## Product Change and Last Time Buy Notice

**PCN #: 0708024**

**Re: VIPAC AC Systems**

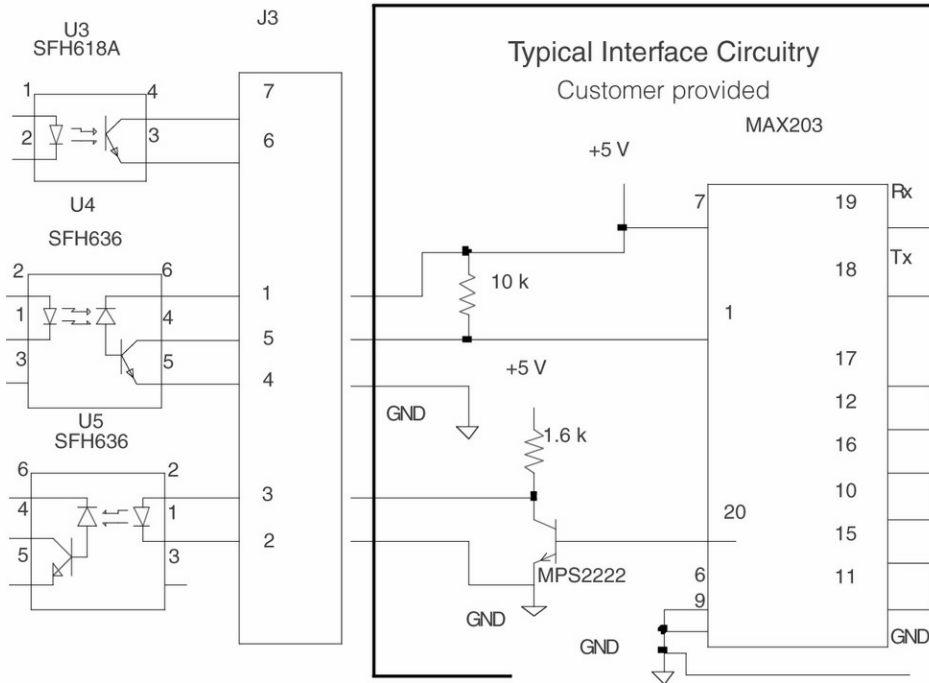
Due to component availability affected by RoHS compliance requirements, the RS232 control interface will be eliminated. Individual converter control will be accomplished through separate control lines connected to internal opto-isolators. See attached drawings.

Option 1: You may continue to order existing VIPACs with the RS232 interface until August 1, 2007 with delivery scheduled not later than November 1, 2007. A 10 pin connector replaces the 7 pin I/O connector, J3. See attached for schematics of the old and new interface. Details are provided in the VIPAC Design Guide available at [www.vicr.com/technical\\_library/guides/](http://www.vicr.com/technical_library/guides/).
